RECEIPT DATE: 3/4/19**ONSITE SEWAGE DISPOSAL SYSTEM**P 564773APPROVAL DATE: 3/18/19 SEC**PERMIT: CONSTRUCTION**

PROPERTY ADDRESS: 15208 Torino WaySUBDIVISION: Fairlane FarmsLOT: 29

**MEMORANDUM**

**RE: 15208 Torino Way**  
**Fairlane Farms, Lot 29**

SEPTIC SYSTEM  
INSTALLATION SITE PLAN  
LOT 29  
15208 TORINO WAY  
FAIRLANE FARMS  
PHASE TWO

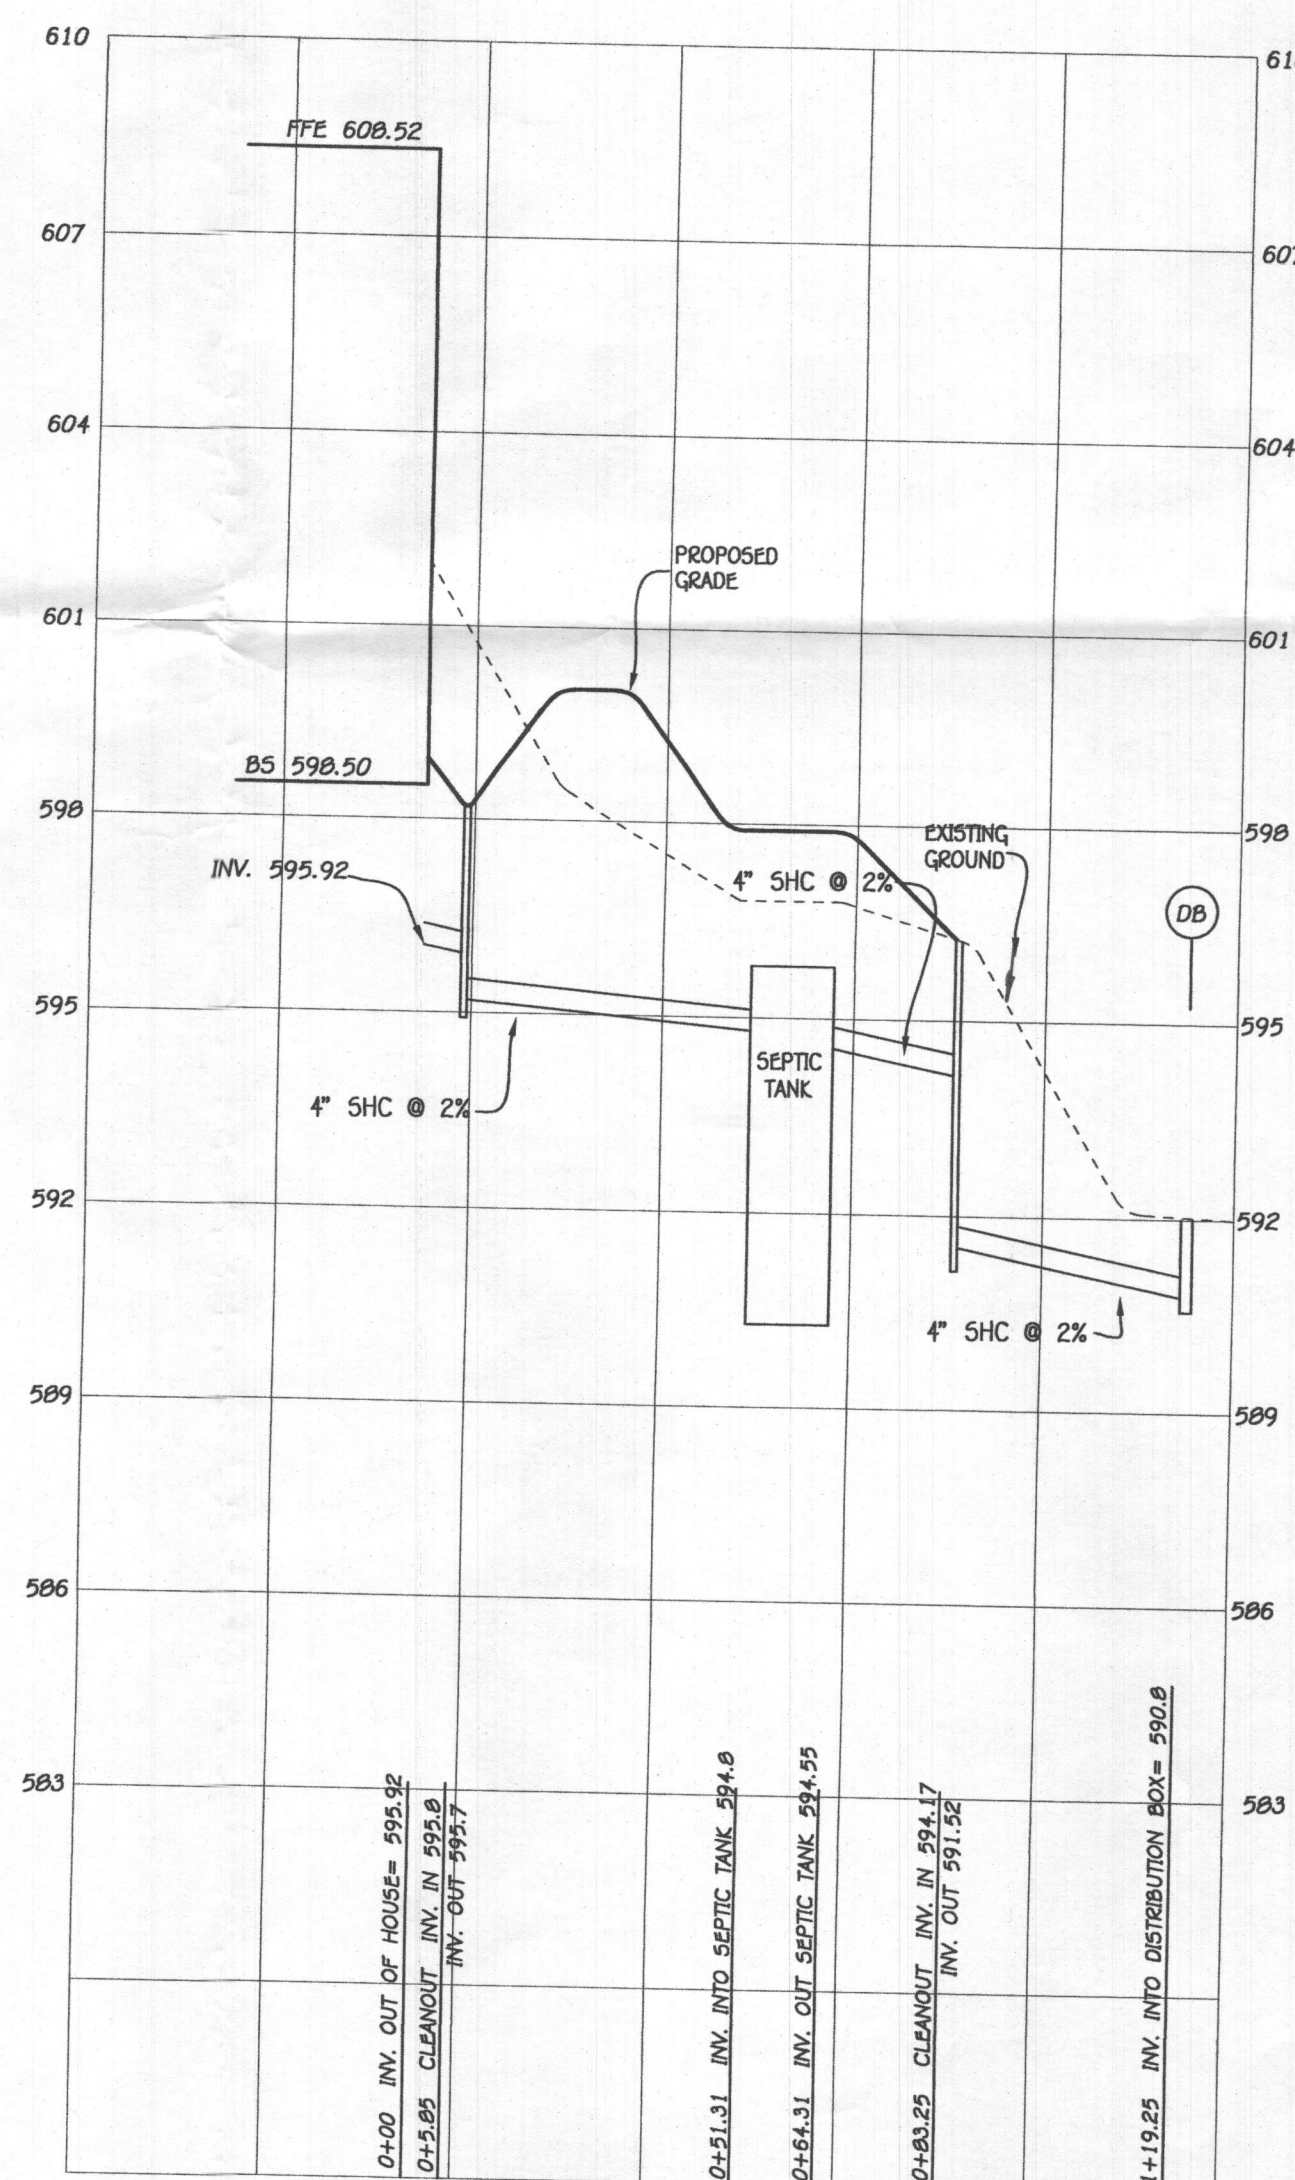
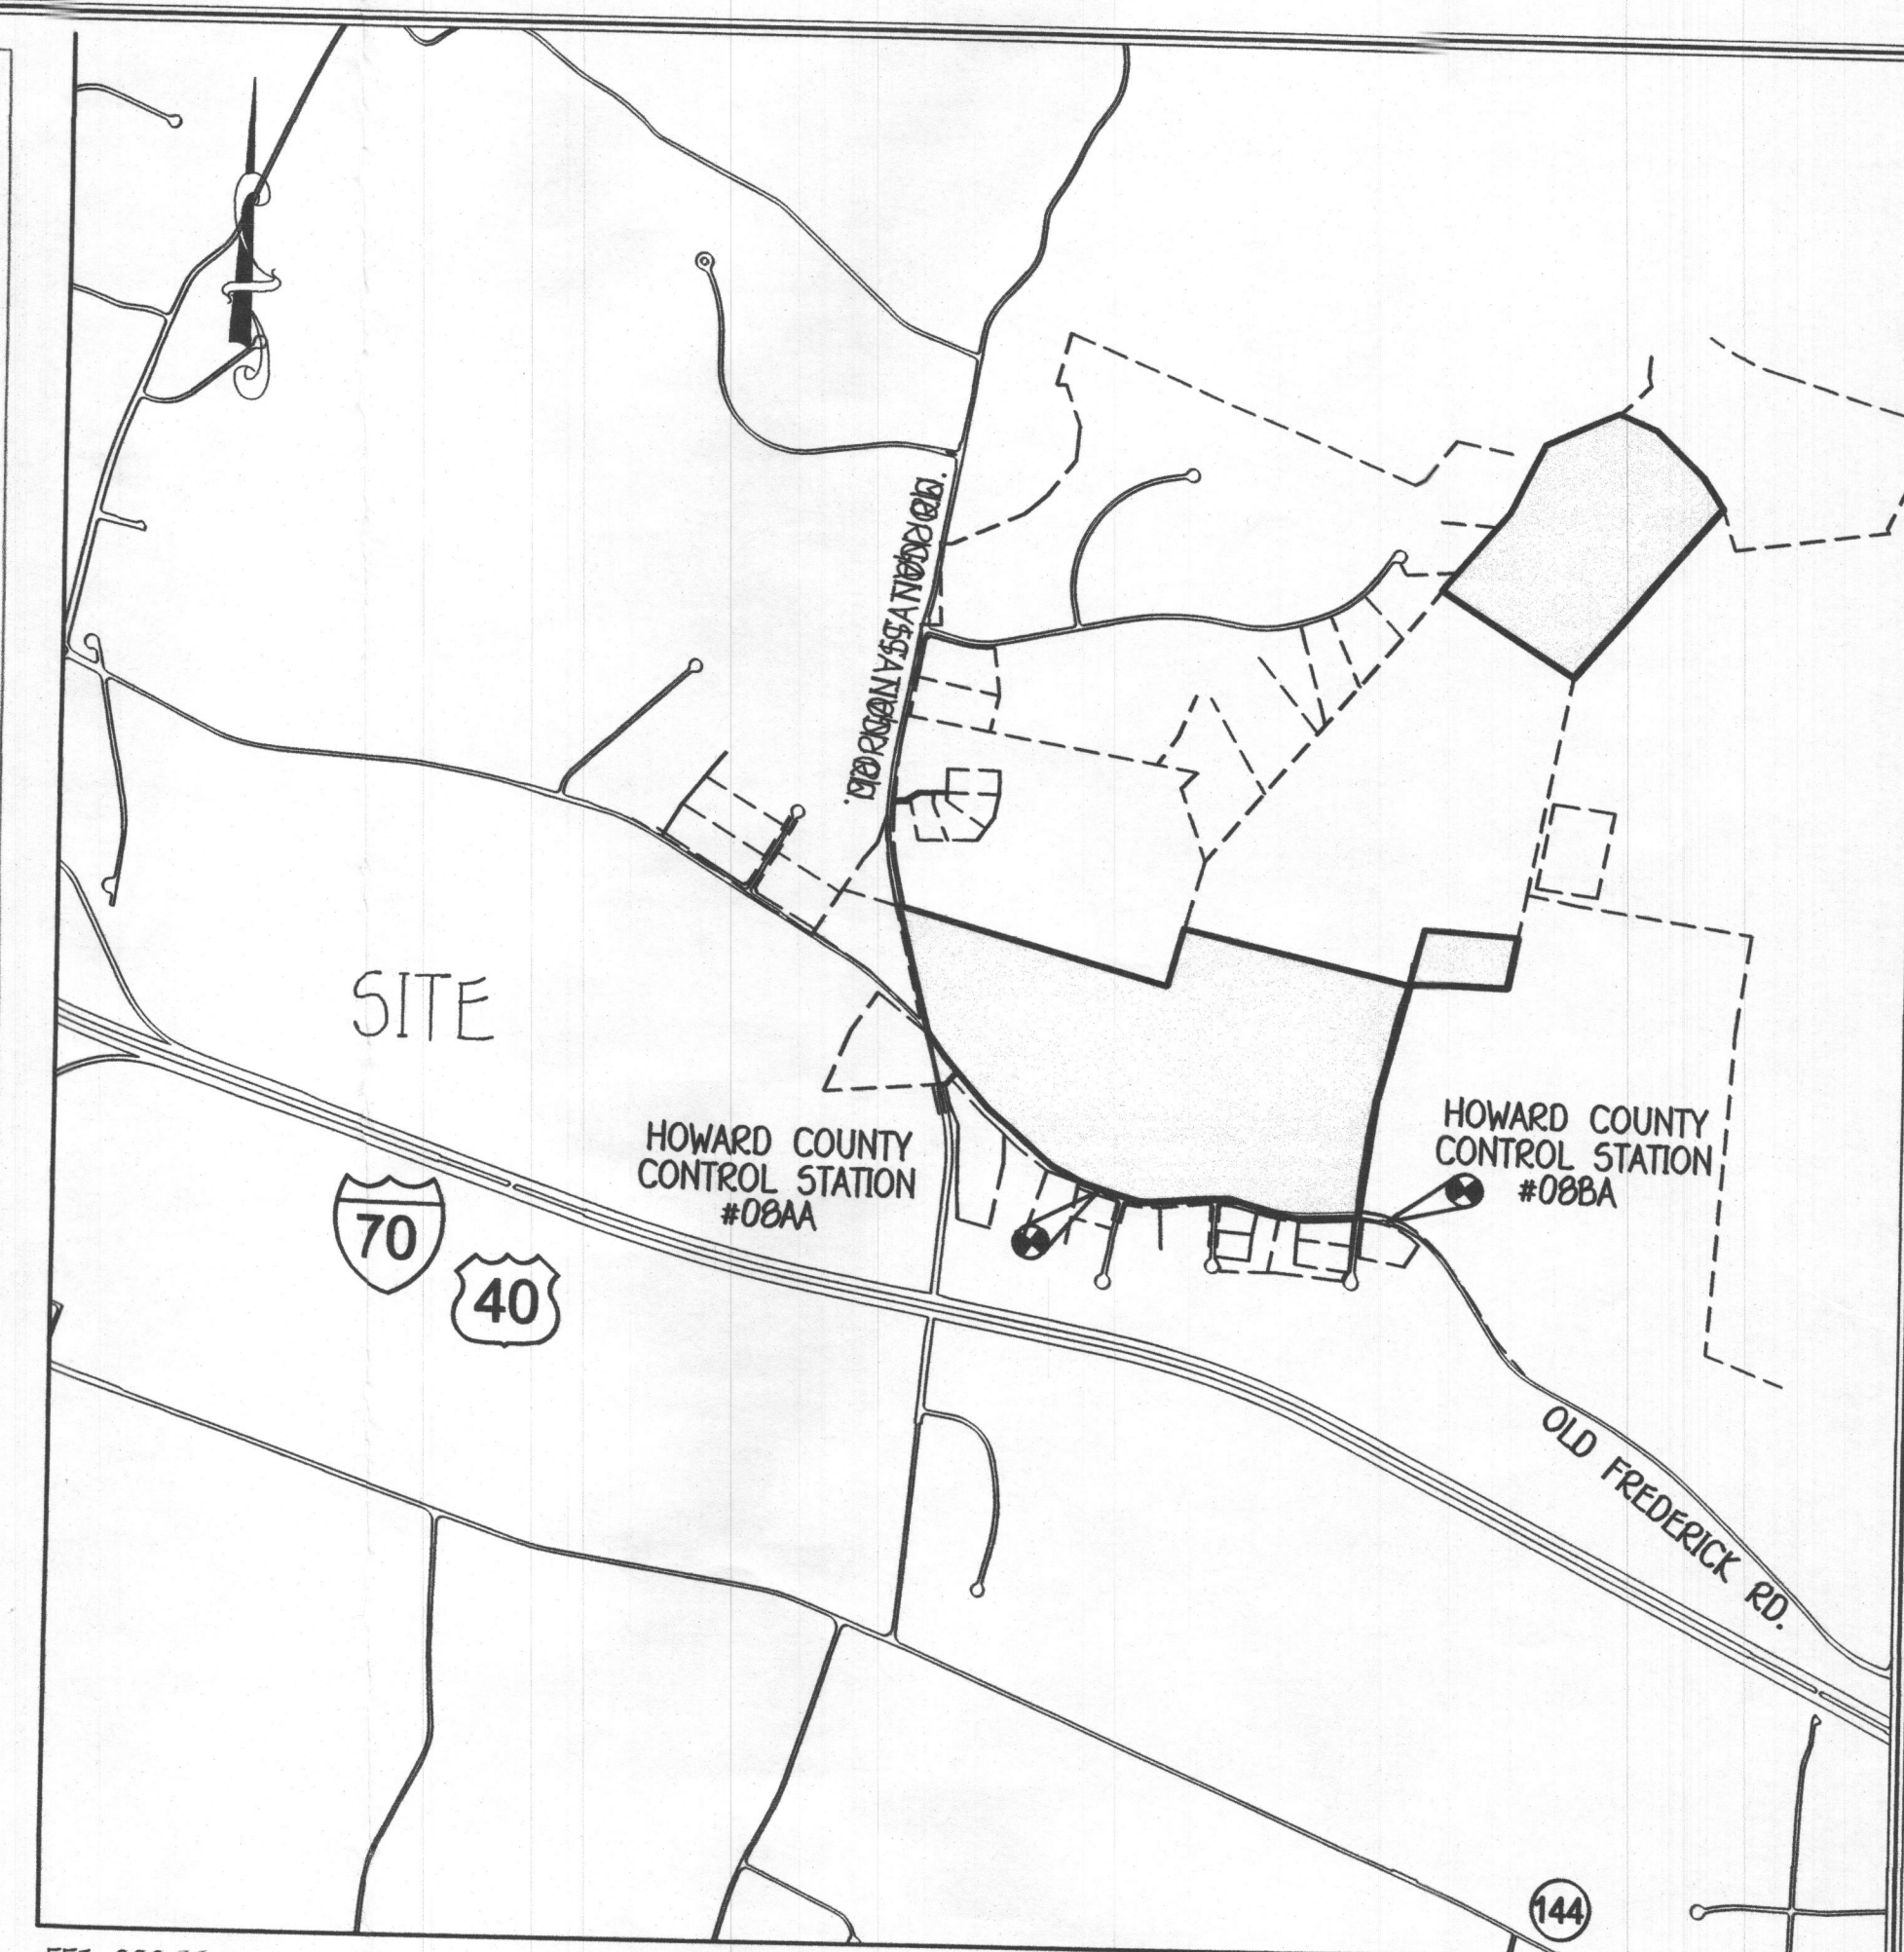
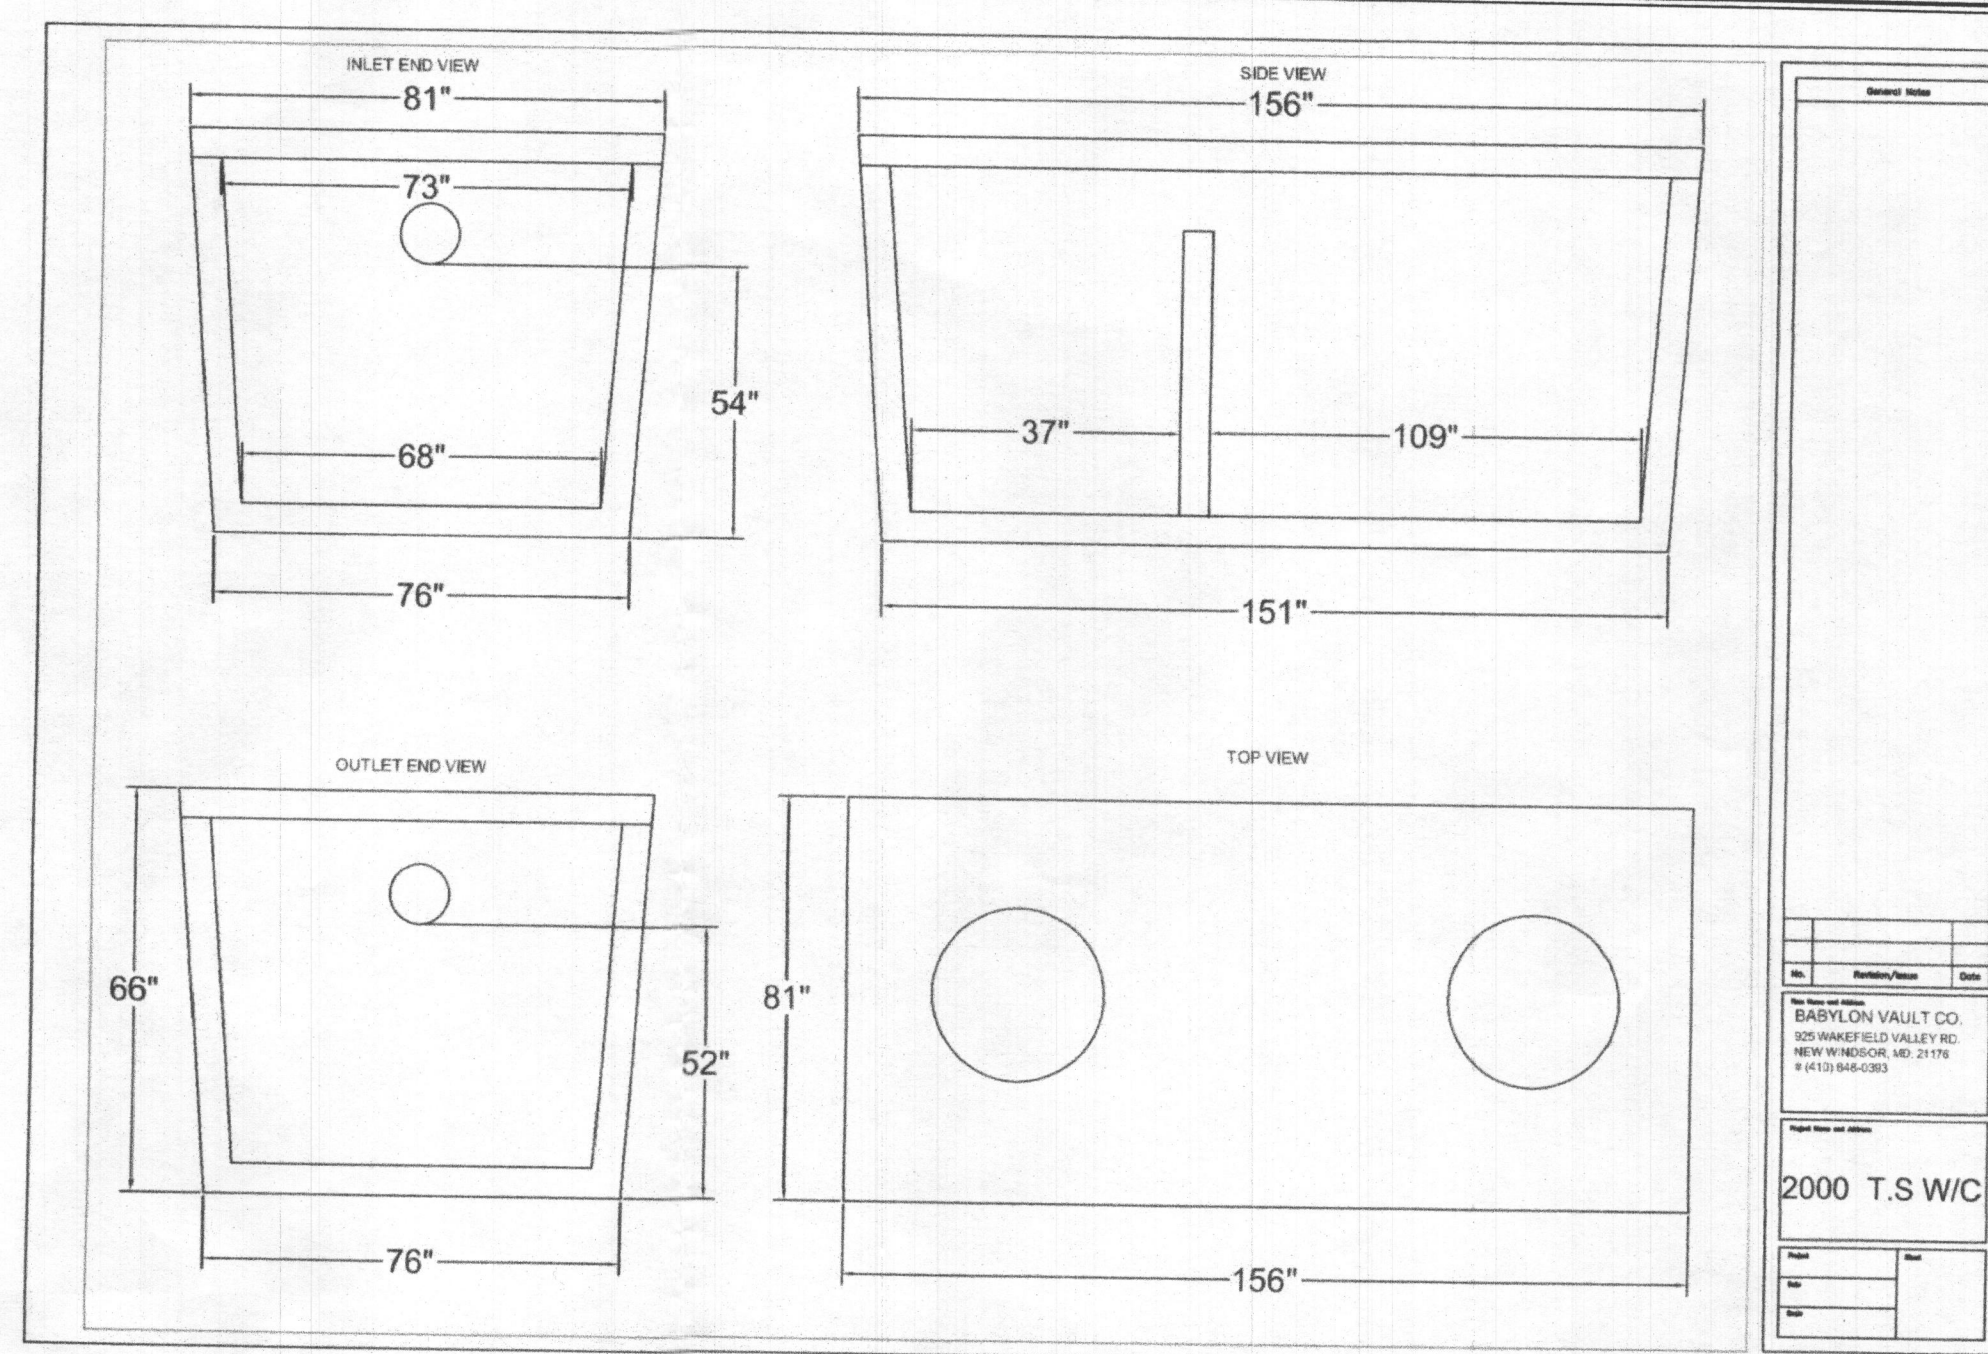
- 1.) Septic Profile doesn't match grading on plan and list of elevations. In addition, the length of pipe between 1<sup>st</sup> cleanout and tank in profile doesn't match length of pipe on plan.
- 2.) Raise d- box. The d-box may not be 5 feet in ground.
- 3.) Raise trench inverts to a minimum depth of 18 inches while maintaining at least 2% fall between tank and d- box.
- 4.) Initial trench reduction credit calculation should be 2 not 3 feet but 0.625 is correct.
- 5.) 1<sup>st</sup> replacement trench spacing calculation should be 11 feet (not 10).
- 6.) 2<sup>nd</sup> replacement reduction credit should be 0.55 (not 1.2). Trench spacing calculation, D = 2.5 (not 2) but 10 feet is correct.
